COMMUNITY BOARD FEEDBACK PACKAGE

DINING OUT NYC

Business Name: ZiZi

Cafe Address: 182 8 AVENUE, NEW YORK, NY, 10011

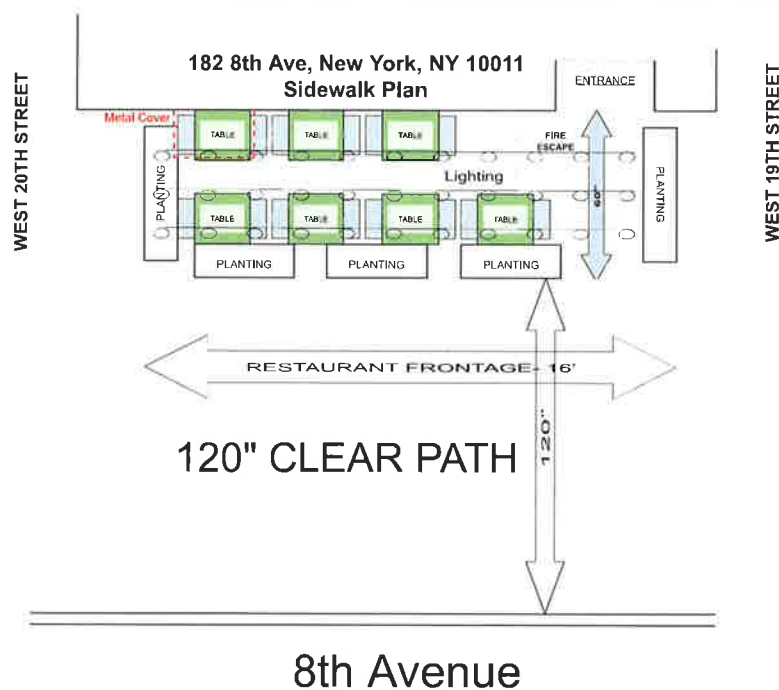
The proposed Site Plan is unrealistic in that it seeks to accommodate two rows of tables and a service aisle in a sidewalk cafe that is only 6 feet wide. The applicant has agreed to remove one row of four tables to resolve this issue and has submitted the attached Revised Site Plan.

The proposed Site Plan is unrealistic in that it seeks to accommodate two rows of tables and a service aisle in a sidewalk cafe that is only 6 feet wide. MCB4 requests that the applicant remove one row of four tables to resolve this issue. The applicant has agreed to this modification and has submitted the attached Revised Site Plan.
